CABINET MEMBER FOR ENVIRONMENT – 13 NOVEMBER 2014

A40 OXFORD NORTHERN BYPASS – BARTON PARK DEVELOPMENT - PROPOSED 50MPH SPEED LIMIT AND TRAFFIC RESTRICTIONS (INCLUDING BUS LANE) AT PROPOSED JUNCTION WITH A40 AND ACCESS ROAD TO FOXWELL DRIVE

**Report by Deputy Director of Environment & Economy
(Commercial)**

TITLE: A40 CORRIDOR & PROPOSED ACCESS JUNCTION SIGN LAYOUT & DESIGN

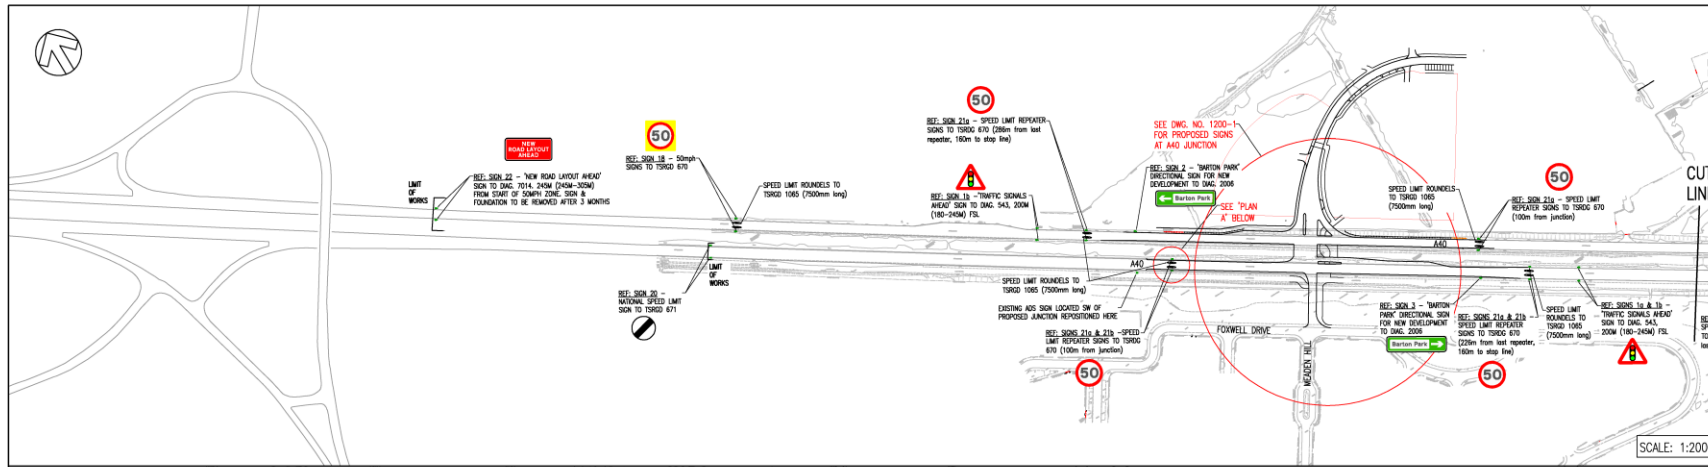
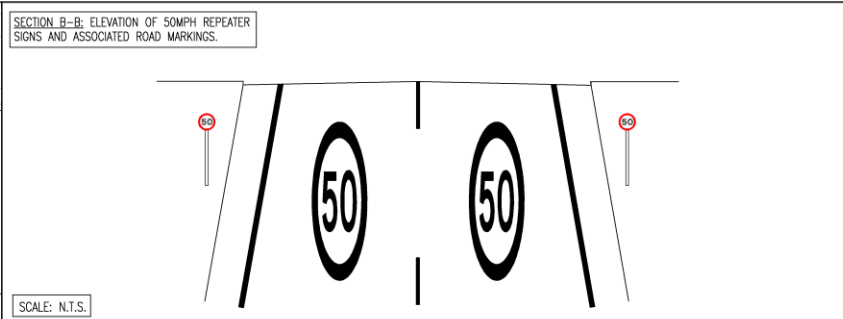
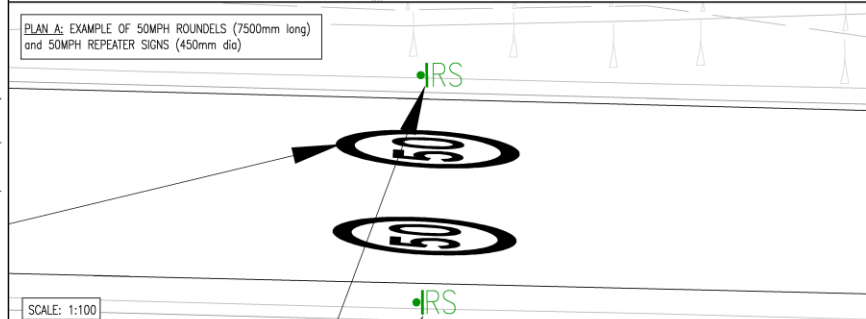
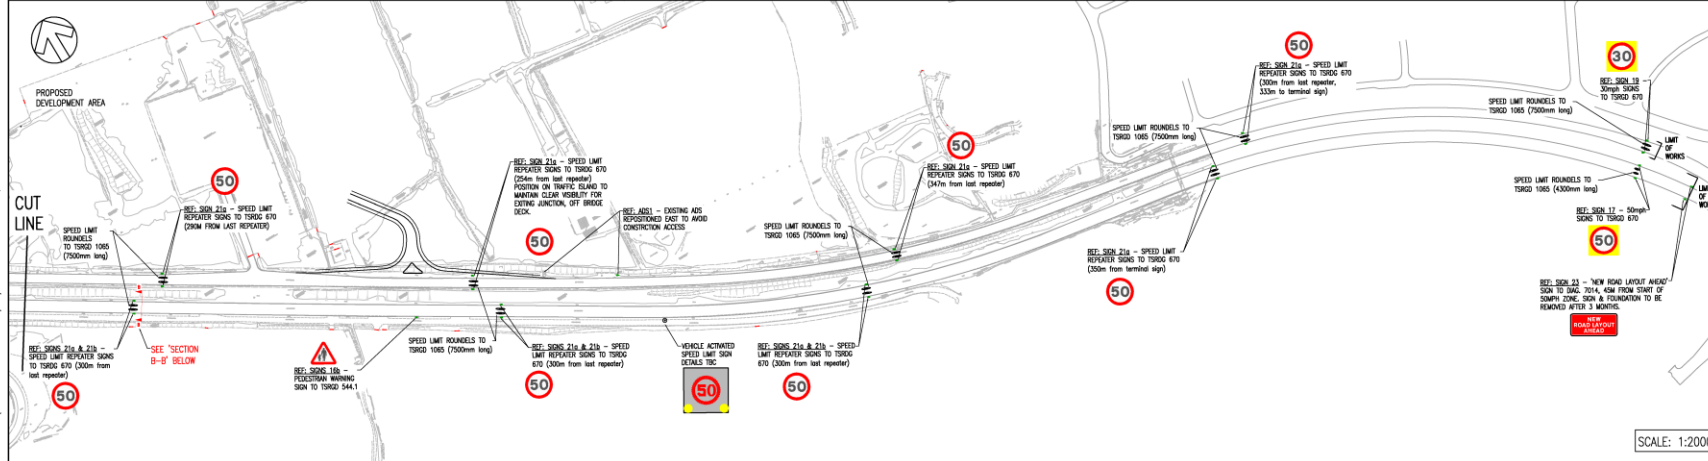
10. The Thames Valley Police objection related to the proposal for a 50mph speed limit on the grounds that the road environment - excepting the proposed junction itself - would not encourage drivers to reduce speed (noting also that no information on current speeds or details of supporting measures to help achieve compliance with the proposed limit had been supplied as part of the consultation). This would both present an on-going expectation for police enforcement, and could compromise safety if the layout of the junction was designed on the basis of the proposed limit, rather than the actual likely speeds.

14. The police concerns over non-compliance and the resulting expectations for enforcement are noted; however as shown in Annex 5, it is proposed to in addition to the standard 50mph repeater signs, carriageway 50mph roundels together with a vehicle activated sign.
